Administrative Design Review Recommendation Packet

PROJECT:
50th Ave S Townhouses
9127 50th Ave S
Seattle, WA 98118

RESPONSE TO SDCI DESIGN GUIDANCE

PROJECT ADDRESSES: 9127 & 9135 50TH AVE S
RECORD NUMBERS: 3032056-EG & 3033376-EG

SITE LAYOUT AND DESCRIPTION

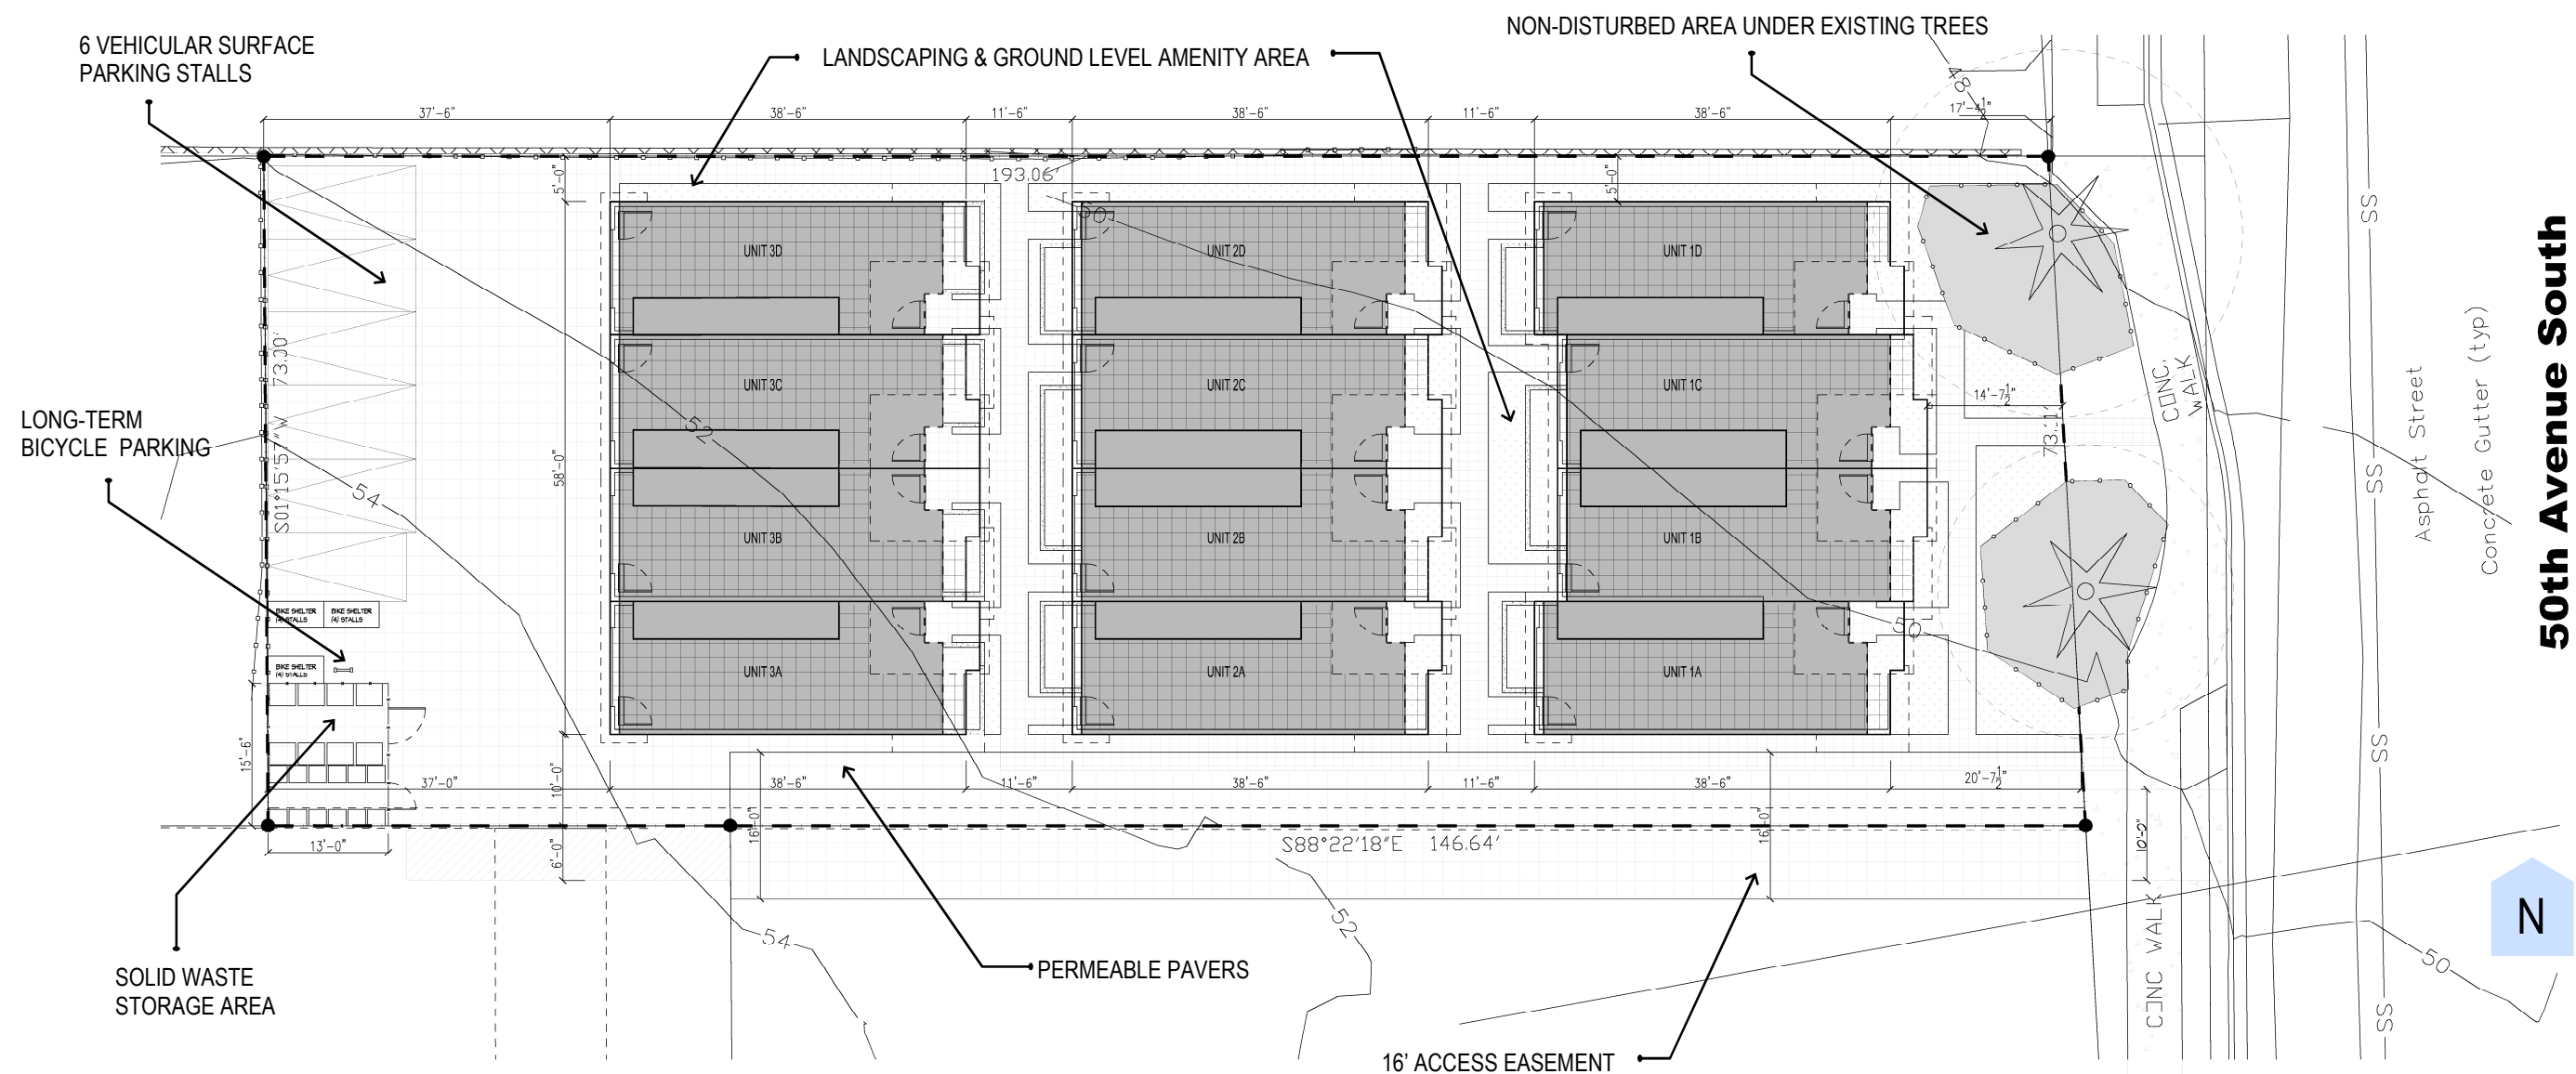
4. PUBLIC LIFE, OPEN SPACE CONCEPT AND LANDSCAPING

PROPOSAL WAS UPDATED TO PROVIDE INDIVIDUAL ENTRY PATHWAYS TO THE STREET FRONTING BUILDING. SHARED PEDESTRIAN PATHWAYS TO THE OTHER BUILDINGS WILL ENCOURAGE OCCUPANTS TO INTERACT AND ENGAGE. YEAR-ROUND LANDSCAPING AND SEASONAL PLANTINGS WILL ADD VISUALLY APPEALING BACK DROPS. BIO-RETENTION PLANTERS ARE NOT ABOVE GROUND, THEREFORE THERE WON'T BE AN OVER ABUNDANCE OF CONCRETE. THE DRIVEWAY IS PROPOSED TO BE COMPRISED OF PERMEABLE PAVERS. THE PEDESTRIAN PATHWAY WILL BE DIFFERENTIATED FROM THE VEHICULAR PORTION WITH A CHANGE IN COLOR AND SIZE OF PAVERS.

THE ENTRY PATHWAYS FOR STREET FRONTING BUILDING HAVE BEEN REVISED TO PROVIDE INDIVIDUAL PATHWAYS TO EACH UNIT. LANDSCAPING HAS BEEN ADDED, WHERE PATHWAYS ONCE WERE.

ALTHOUGH WE UNDERSTAND YOUR REQUEST FOR THE DIFFERENTIATED PEDESTRIAN PATHWAY TO BE ELEVATED FROM THE VEHICULAR PORTION, IT IS NOT FEASIBLE DUE TO OUR REQUIRED 16' WIDE ACCESS EASEMENT. THE LAND USE CODE DOES ALLOW FOR A PEDESTRIAN PATHWAY TO BE PART OF A DRIVEWAY AS LONG AS IT'S DIFFERENTIATED IN COLOR AND SCALE.

EACH UNIT HAS A ROOF TOP DECK FOR PRIVATE AMENITY AREA USE. THE SPACE BETWEEN THE BUILDINGS HAS BEEN DESIGNATED AS COMMON, WITH A SHARED PEDESTRIAN ACCESS PATHWAY. NEIGHBORS CAN CONGREGATE IN THESE FULLY ILLUMINATED AND LANDSCAPED AREAS. |

COLOR ELEVATIONS

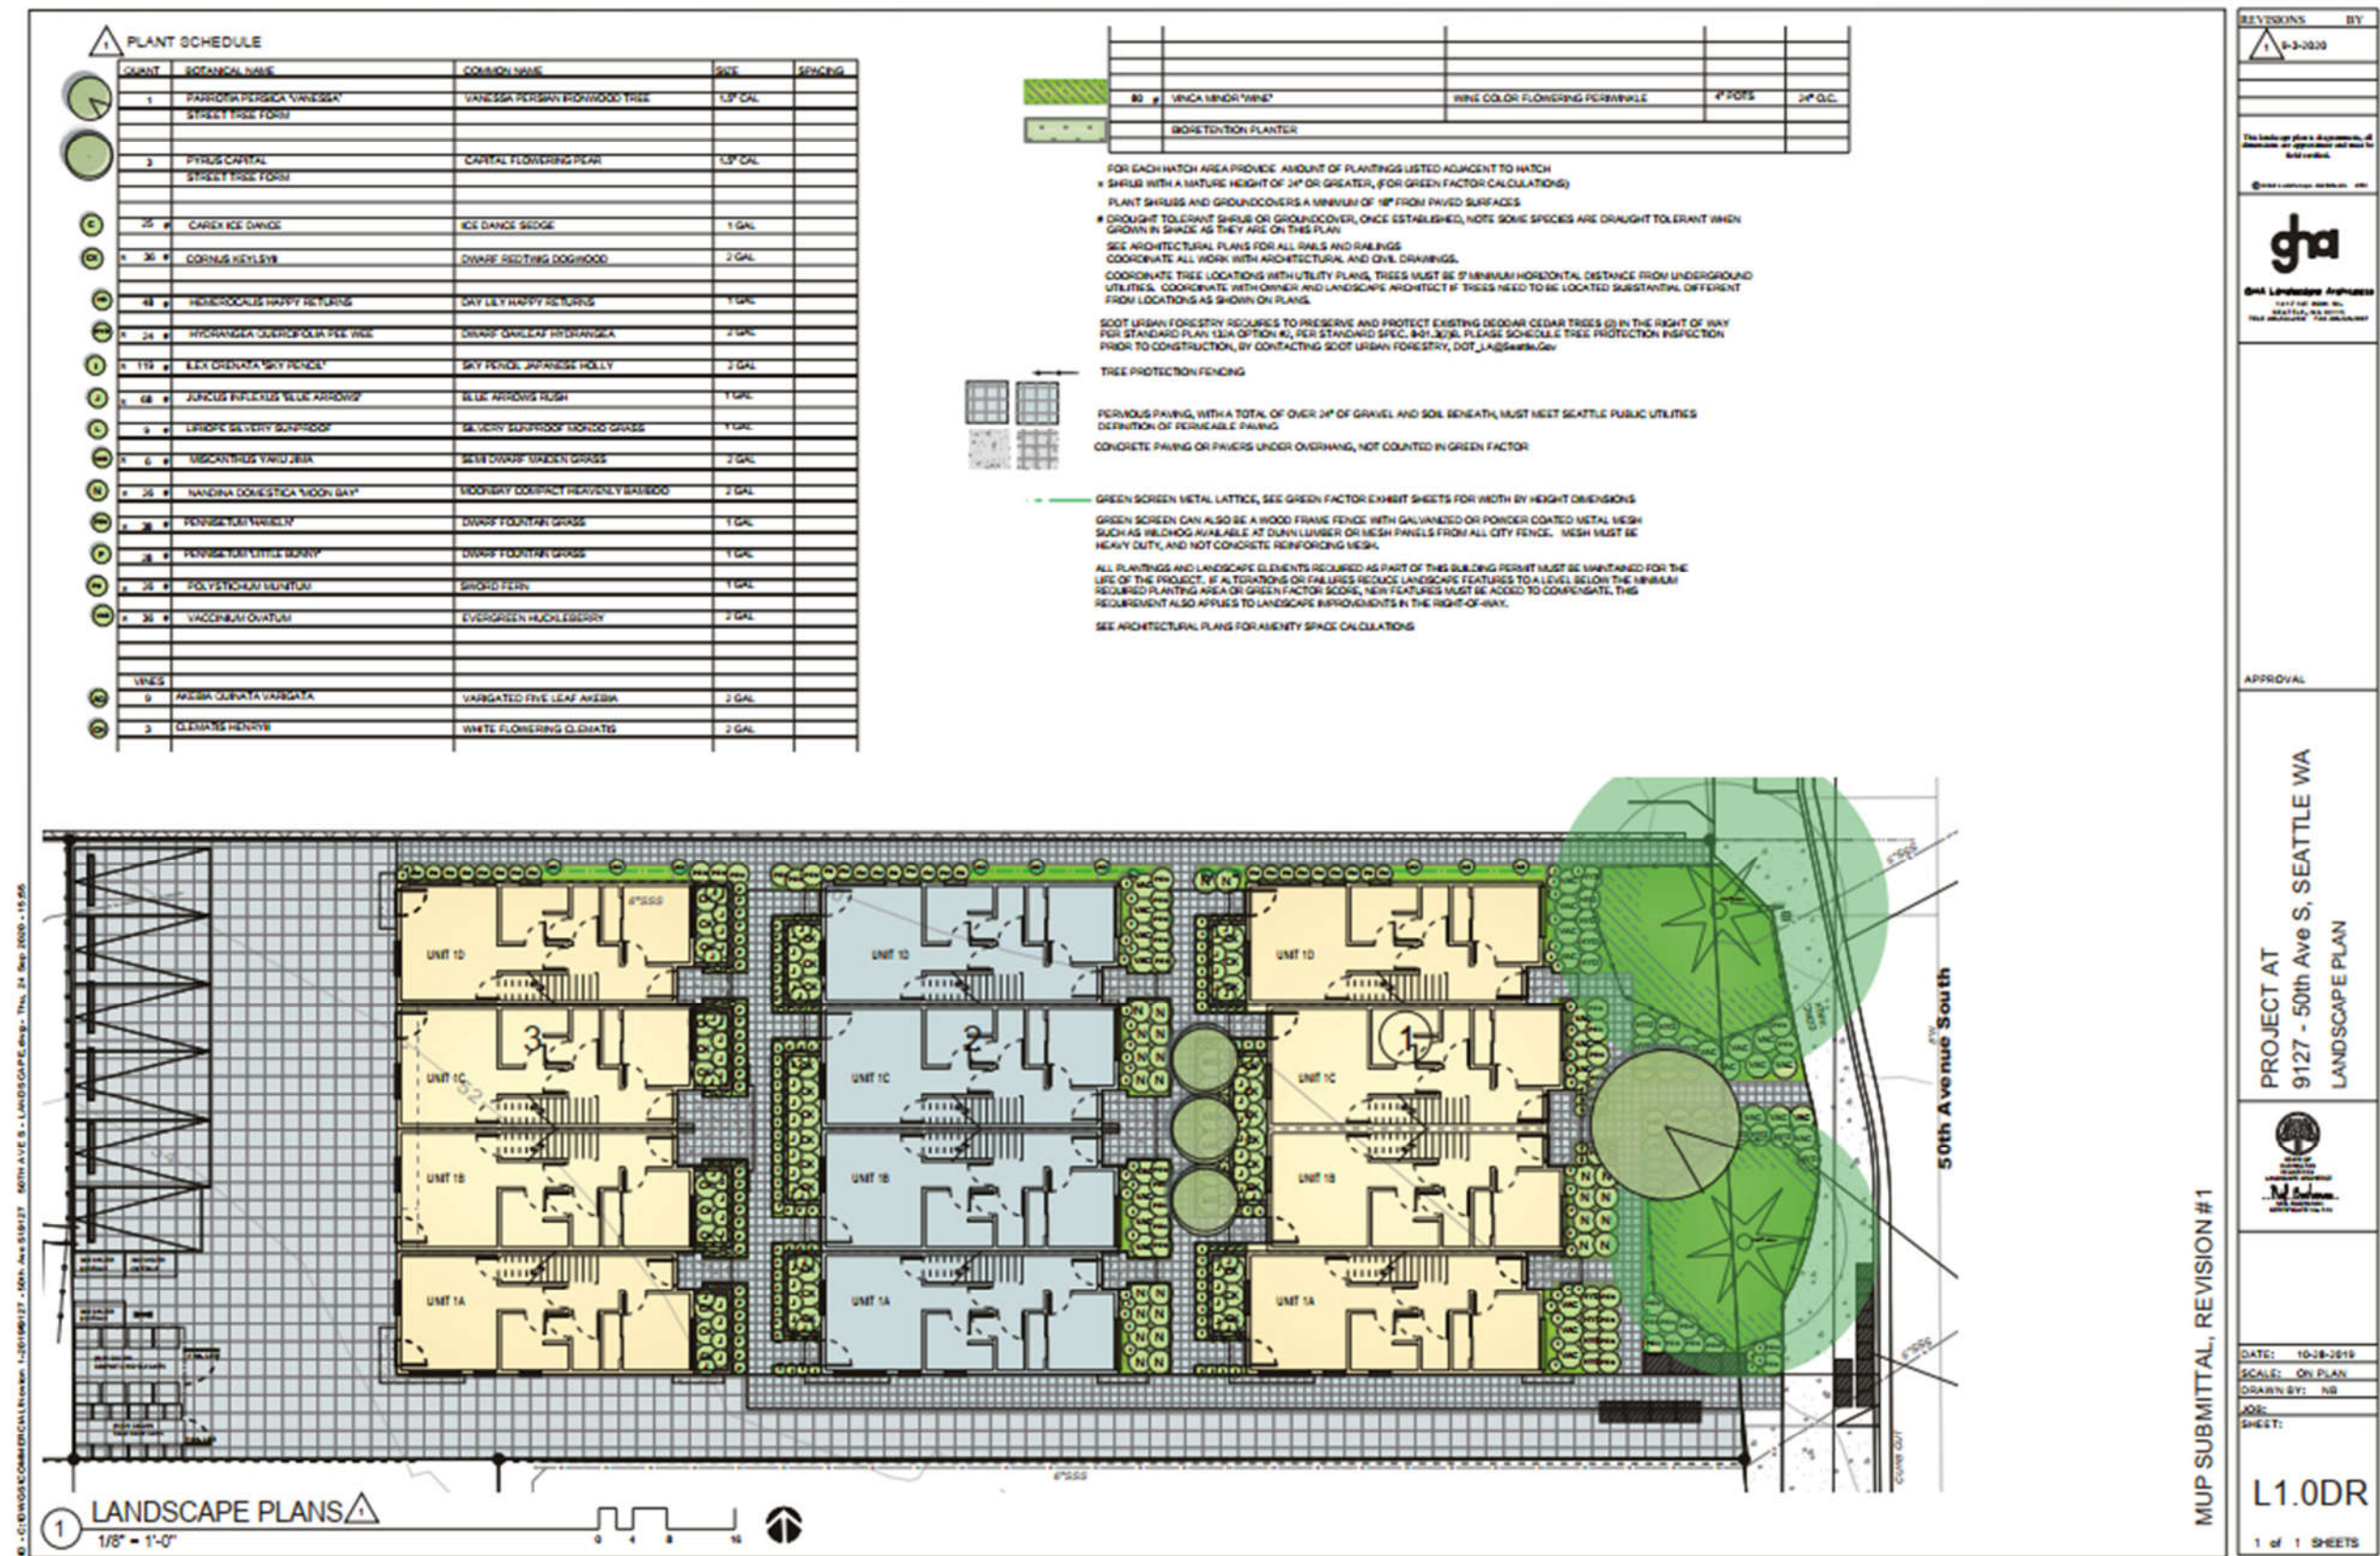
2. FAÇADE TREATMENT AND SECONDARY ARCHITECTURAL FEATURES

THE PROPOSED FAÇADE COMPOSITION PROVIDES MANY ELEMENTS TO ENSURE THE FACADES ARE ATTRACTIVE AND WELL PROPORTIONED BY A CHANGE IN MATERIAL AND COLOR, MODULATION OF FLOORS, ARCHITECTURAL FEATURES AND ROOF OVERHANGS.

THE PROPOSED BUILDINGS HAVE RECESSED ENTRIES AND CLEARLY IDENTIFIABLE ENTRY PATHWAYS. THE EXISTING AND PROPOSED LANDSCAPING WILL HELP TO TRANSITION THE SCALE OF THE NEW BUILDINGS IN RELATION TO PEDESTRIANS AT STREET LEVEL. THE PROPOSED CEMENT BOARD AT GROUND LEVEL WAS REDUCED IN SCALE, FROM THE EDG PROPOSAL PACKET. THE CHOSEN COLOR HAS A MATTE FINISH, AND IS NOT OVERLY VIBRANT. THIS WILL AID IN NOT OVERWHELMING THE NEIGHBORING PROPERTIES.

THE CEMENT BOARD SIDING THAT HAS BEEN CHOSEN IS A DURABLE MATERIAL THAT WILL HOLD UP AGAINST SEATTLE'S CLIMATE. THE DETAILING OF THE BEIGE HORIZONTAL WOOD SIDING AND THE BROWN PANELS HELP TO BREAK UP THE LARGE FACADES. THE PROPOSAL LIMITS THE NUMBER OF COLORS USED, BUT ALTERNATES THEM TO DIFFERENTIATE PORTIONS OF THE FAÇADE AS WELL AS REDUCE THE MASSING EFFECT ON NEIGHBORING PROPERTIES AND THE ROW.

ADDITIONAL WINDOWS ARE PROPOSED ON THE 2ND AND 3RD FLOORS TO AID IN BREAKING UP THE BLANK FAÇADE FACING THE STREET. PER OUR DESIGN STANDARDS PAGE IN THE PLAN SET, OUR OPENING PERCENTAGE IS 27.8% OF THE EAST STREET FACING FAÇADE.
